ADDENDUM NUMBER 01

PROJECT: **RICKWOOD CAVERNS STATE PARK – POOL HOUSE**

PROJECT NUMBER: **ASPD PROJECT #: 2025-022-1616**

This Addendum forms a part of the Contract Documents and modifies the Bidding Documents dated **December 19, 2025 (Plans) and April 28, 2026 (Project Manual)**.

5 EAVE AND GUTTER DETAIL
3" = 1'-0"

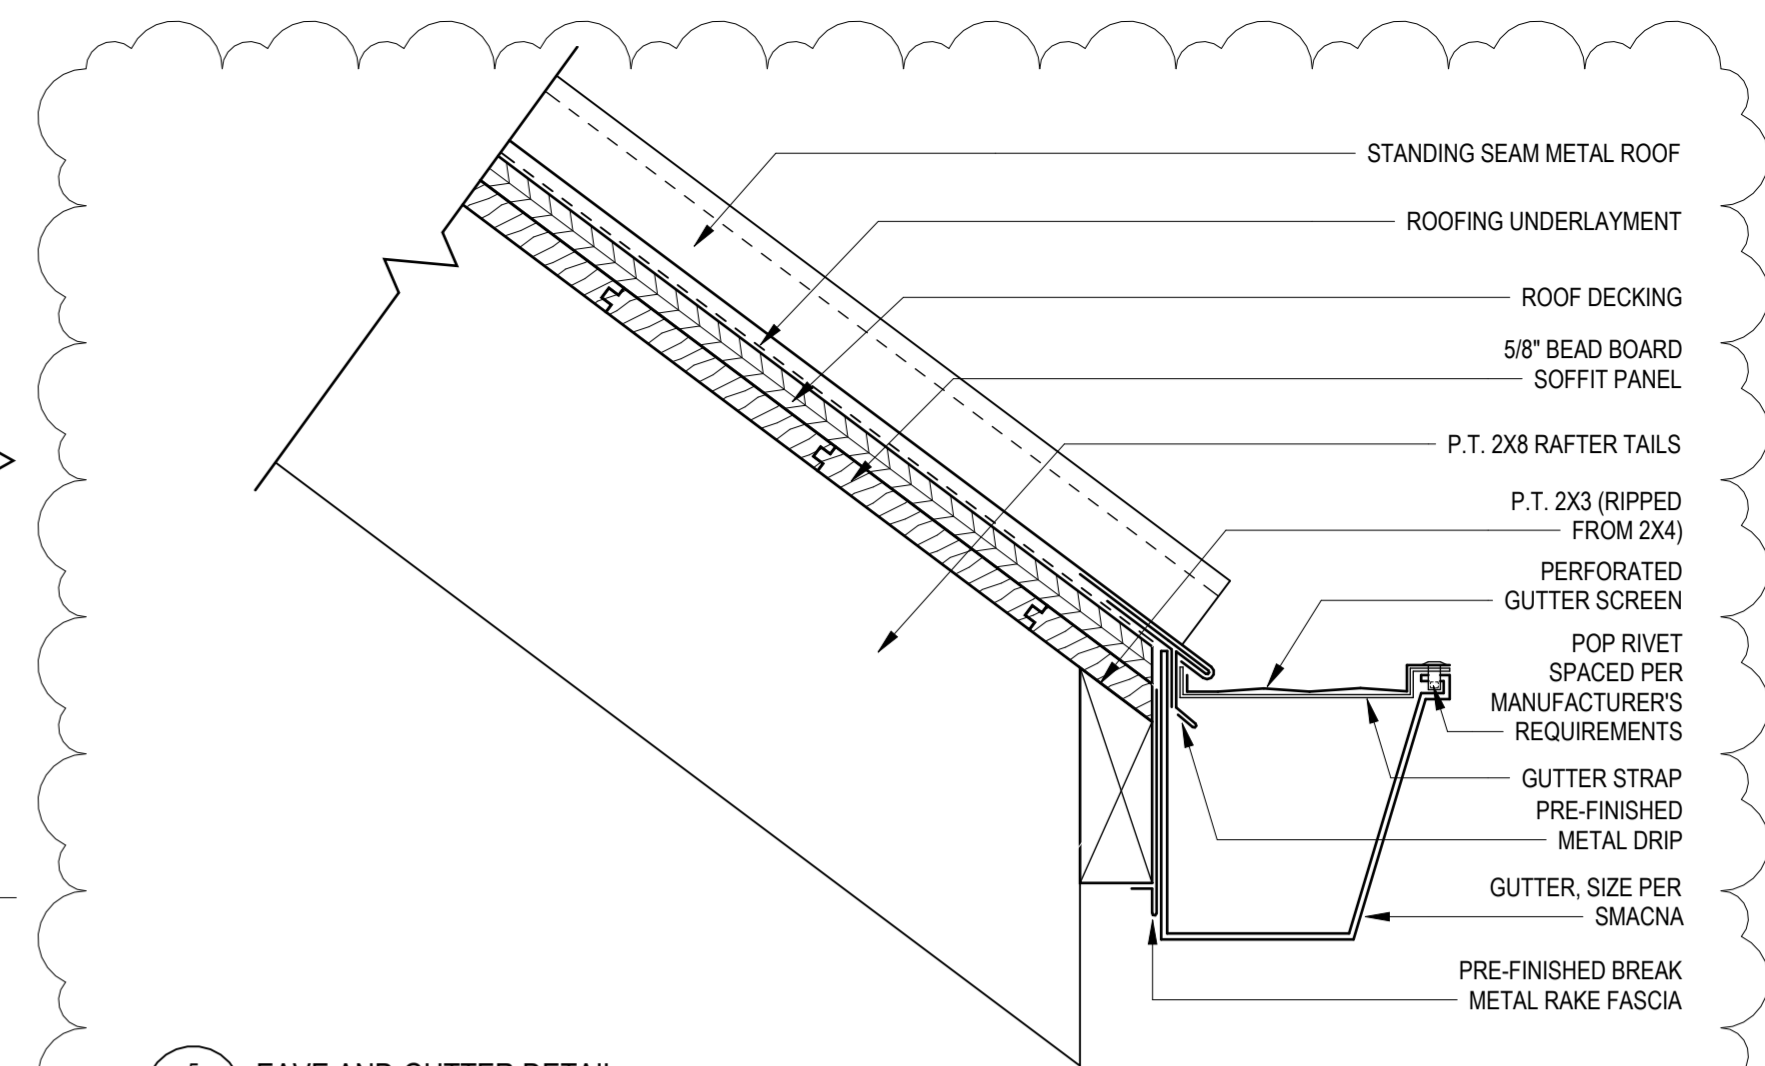
1. Sheet A05.10
 - a. Replace this sheet in its entirety with the attached version.
 - b. Section 2/A05.10: Gutter guards have been added.
 - c. Detail 5/A05.10: Gutter Guards have been added and indicated.
